Technical Service Bulletin

Circulate To:	Service Manager	x	Parts Manager		Series:	Momentum
	Warranty Admin	x	Technician	x	Model:	Line 12 built TT's only
	Sales Manager				Build Date	*10/2025

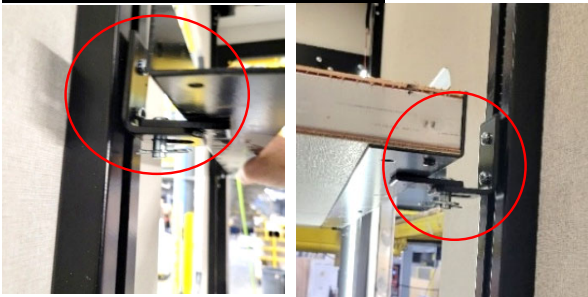
Concern: It has been identified that certain Line 12 Momentum TT's may have the Happijac top bunk L-brackets installed in an inverted (upside-down) orientation. The reduced clearance condition can cause mechanical interference at the top of travel, preventing the bunk from properly disengaging from the locking mechanism.

Remedy: Inspect the orientation of the Happijac top bunk L-brackets. If brackets are found to be inverted, remove and reinstall in the correct orientation per manufacturer specifications to restore proper clearance and ensure normal disengagement of the locking mechanism at full upward travel.

- Step 1:** To correct this, you will need to pull the cotter pin out of the clevis pin
- Step 2:** Lift the bed decking rail to get to the mounting screws on the bracket and back out the screws.
- Step 3:** Flip the bracket to its correct position, making sure to keep the spacer block in place, reinstall both screws.
- Step 4:** Lower bed decking back into place and reinstall washer and cotter pin into the clevis pin. Repeat process on all 4 brackets.
